2018-19 Design, Build, Fly Q&A #2

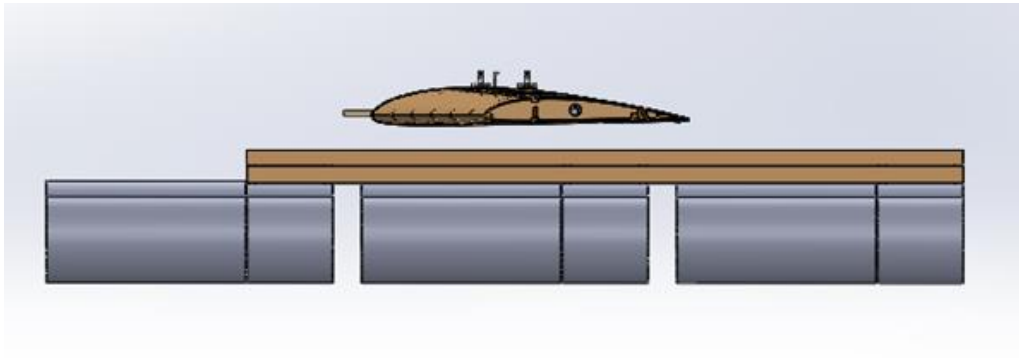
1. Could part of the bomb be not exactly under the wing as below (Assume the armament is attached to the wing, unlike in the picture)? Some stores are not entirely under, but attached through an armament to the wing. Would it violate the interpretation of Rules under question 25?

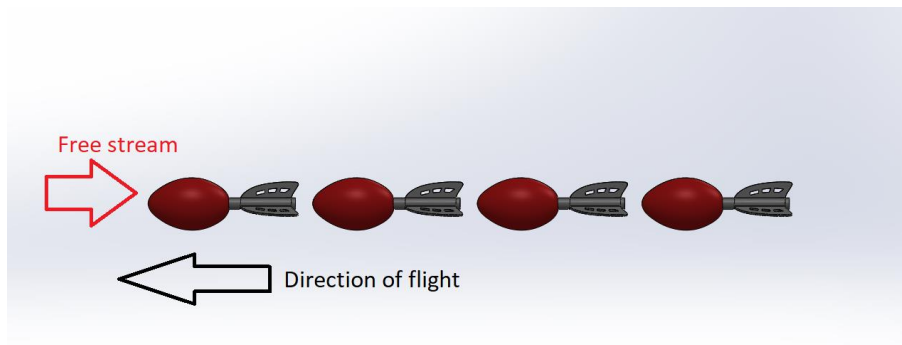
In the rules its mentioned about the spacing between the rockets and the aircraft. Can we mount the rockets in tandem configuration according to the spacing in the rules. Four of the rockets will be under the wing and the rest will be mounted in tandem configuration or we have to mount all of them side by side under the wing?

Can we place the attack stores in the arrangement shown below, with the tip following the rear of the next stores?

Answer: For the minimum requirement of four stores, these first four must be mounted laterally under the plane of the wing. There must be two on each side of the fuselage centerline as notionally shown below. The stores must have lateral separation (cannot be in line as shown above). For additional stores over the four minimum, these can be aligned behind other stores as also notionally shown below.

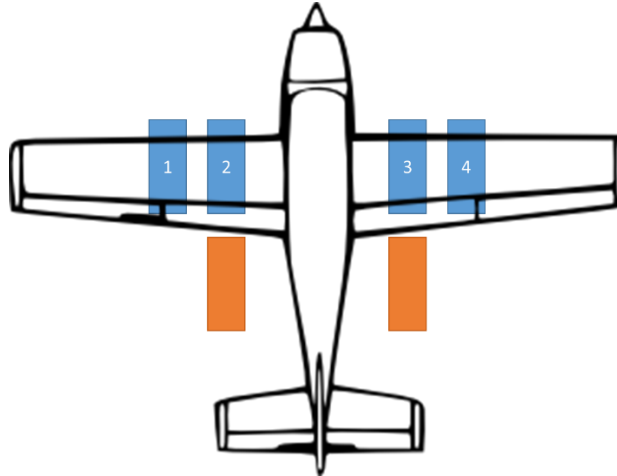
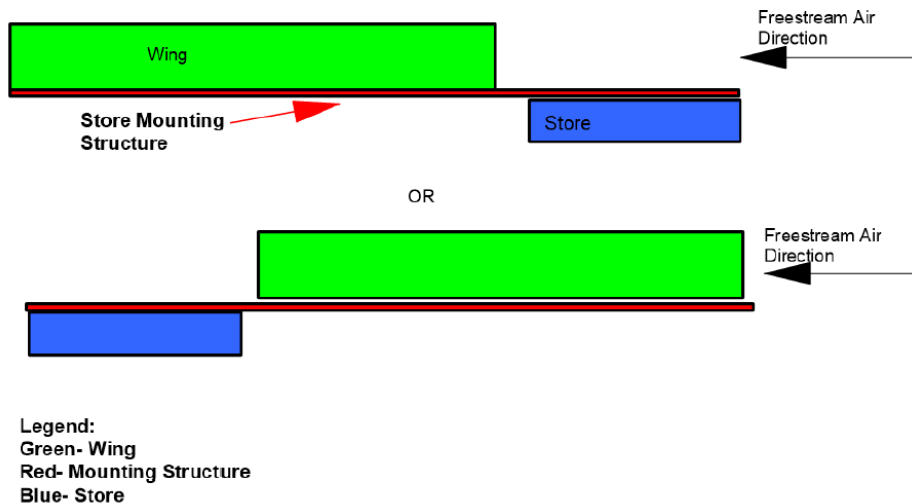
- For mission 3, is the attack store allowed to not be under the projected area of the wing but still physically under the wing? i.e. if the attaching mechanism protruded in front of the leading edge or behind the trailing edge of the wing and the attack store is also protruding but still attach below the wing does this still count as "under the wing." This situation is shown in figure [below].

Answer: As long as the mounting structure is attached to the wing and the store is under the plane of the wing, it is allowed (as shown in the picture above)

Figure 2. Attack store placement

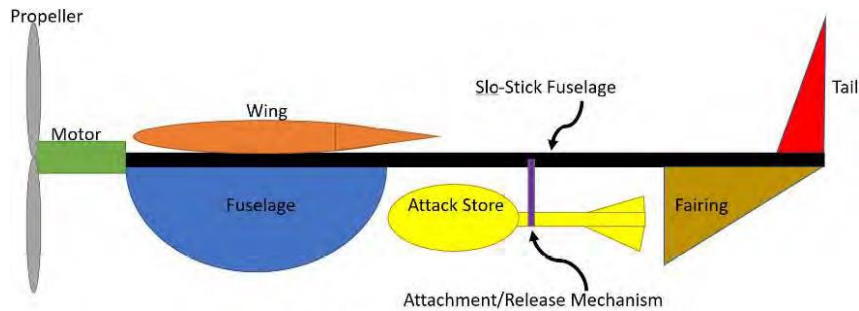
- The attack store shown in this photo in Q&A-1 is blocked by the fuselage. Does the attack stores counted as under free stream in this case?

Answer: As long as the stores are under and attached to the wing or fuselage via an attach structure as shown, it is allowed.

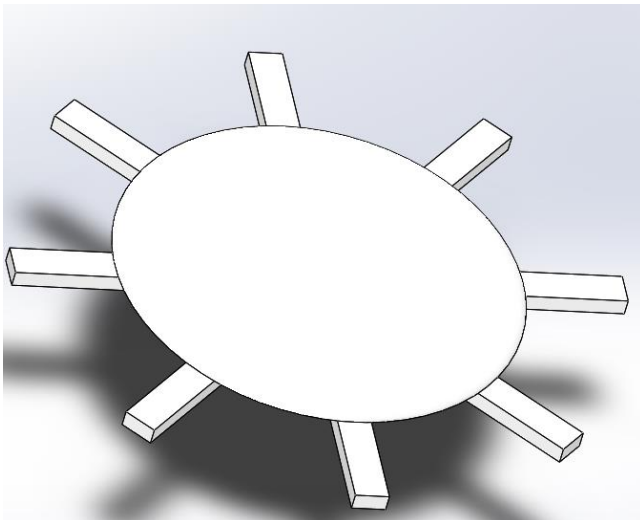
10. From the rules, the radome "Must be 12 inch minimum diameter and 1 inch minimum thickness in the center (attachment point)". Is this shape allowed?

Given that it looks a bit strange, a would the following modification be allowed

Answer: Neither of these shapes are allowed. The radome must be a 12 inch continuous circle.

Figure 1

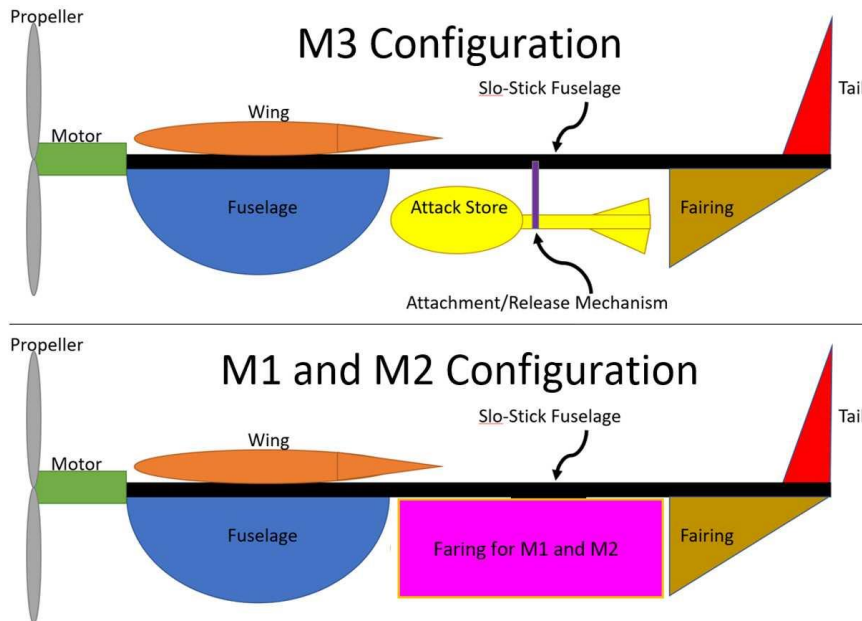
Can a fairing be added in place of an attack store for M1 and M2 when teams don't need to carry the attack store so that there isn't a void as shown in Figure [below]?

Answer: Other than the stores and radome and batteries and propellers, the aircraft cannot change configurations for each mission.

Figure 2

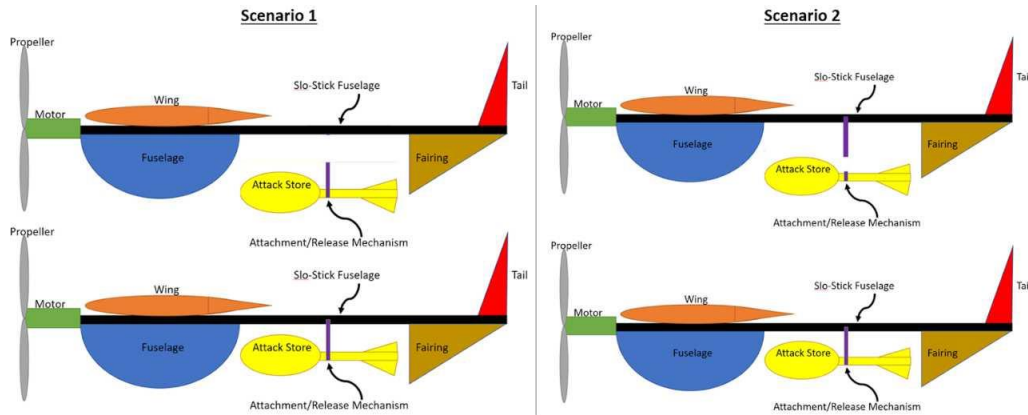
29. When attaching stores for the ground mission (see Figure 2), can we attach both the mounting hardware and the stores onto the aircraft at the same time since we can remove the hardware for M1 and M2 (Scenario 1) or does the mounting hardware need to already be on the aircraft and only the store can be attached (Scenario 2)?

Answer: Scenario 2. Only the stores are not attached when entering the staging area.
